**SUSQUEHANNA STEAM ELECTRIC STATION  
SUBMITTAL OF UNIT 2 CYCLE 19 CORE  
OPERATING LIMITS REPORT, REVISION 1  
PLA-7765**

**Docket No. 50-388**

**Unit 2 Cycle 19 COLR, Revision 1**

# Susquehanna SES Unit 2 Cycle 19

FLOW DEPENDENT LHGR LIMIT MULTIPLIER  
 MAIN TURBINE BYPASS / EOC-RPT / BACKUP PRESSURE REGULATOR OPERABLE  
 ATRIUM™-10 FUEL  
 FIGURE 6.2-2

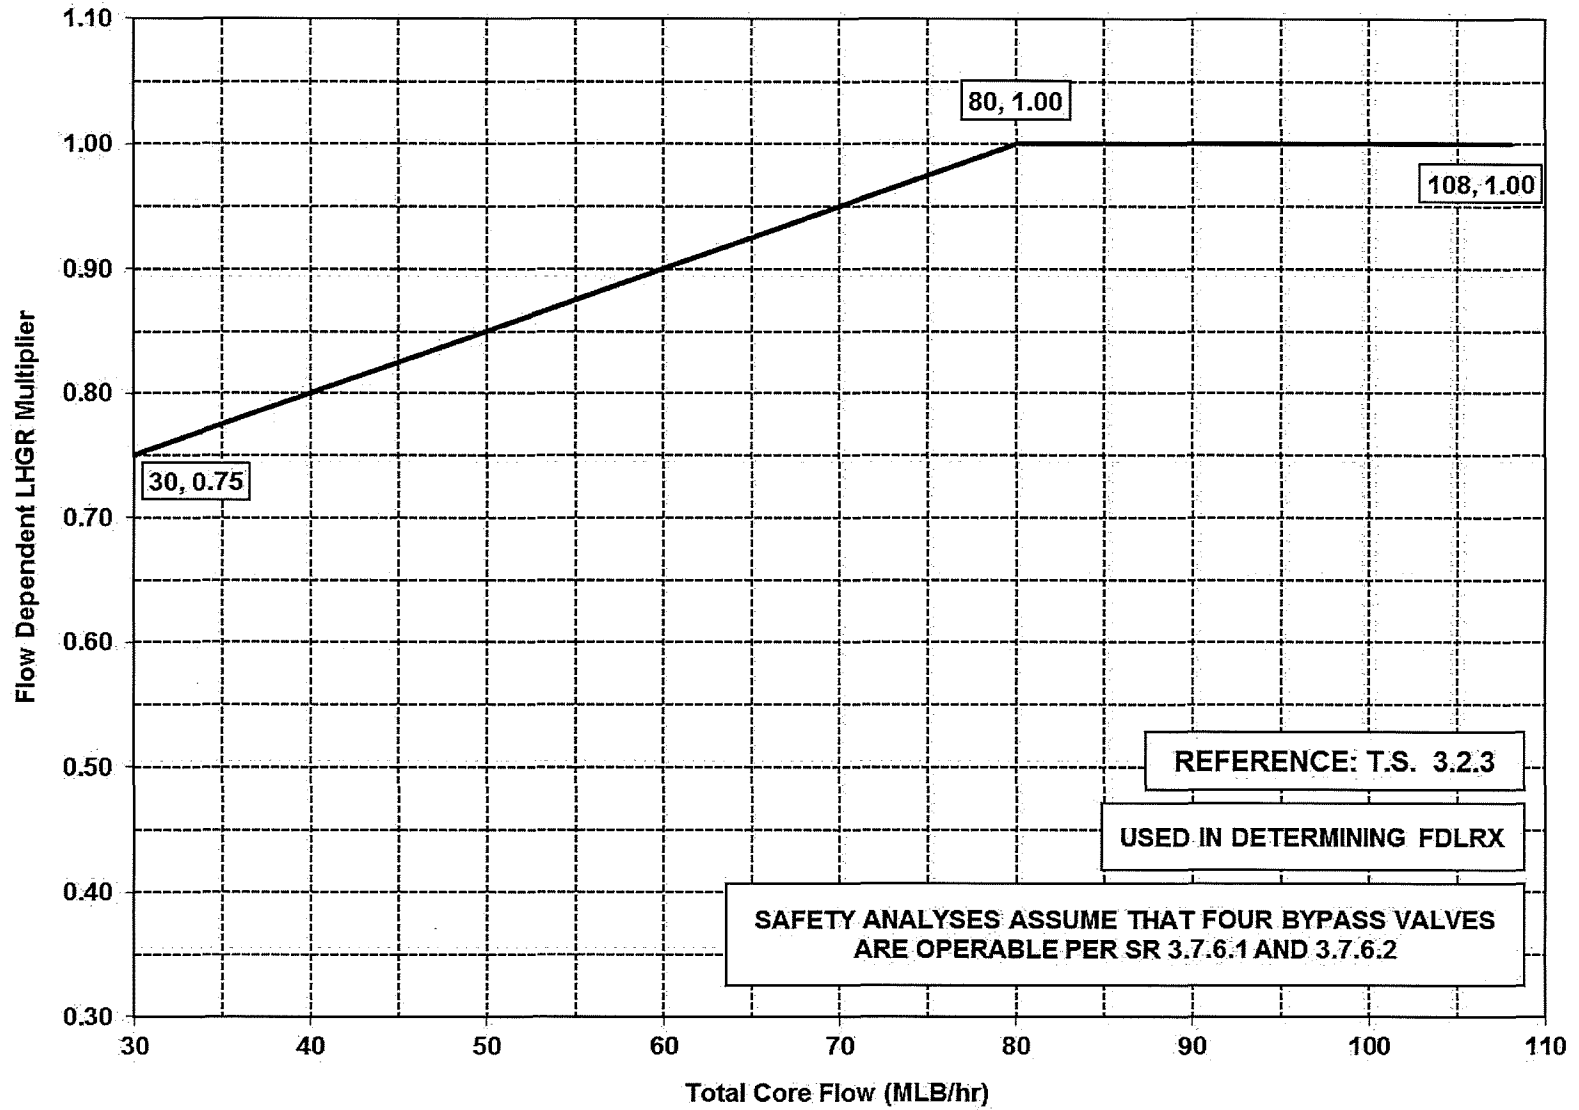
<b>CORE OPERATING LIMITS REPORT REVISION DESCRIPTION INDEX</b>		
<b>Rev. No.</b>	<b>Affected Sections</b>	<b>Description/Purpose of Revision</b>
0	ALL	Issuance of this COLR is in support of Unit 2 Cycle 19 operation.
1	6.0  ALL	<p>Figures 6.2-2 through 6.2-4 (editorial) and 6.2-5 (technical) are revised to account for the cycle achieving a greater core average exposure than what was assumed to initially analyze Unit 2 Cycle 19 (U2C19). Updated U2C19 licensing analysis results (Framatome, formerly AREVA, report ANP-3536, Rev. 3) at a bounding core average exposure only affect the power-dependent, equipment out-of-service Linear Heat Generation Rate (LHGR) multipliers.</p> <p>On pages 27, 29, and 32, text supporting these Figures is also updated.</p> <p>Removed page count prefix TRM/ and Effective Date from footer to align formatting with the new process.</p>
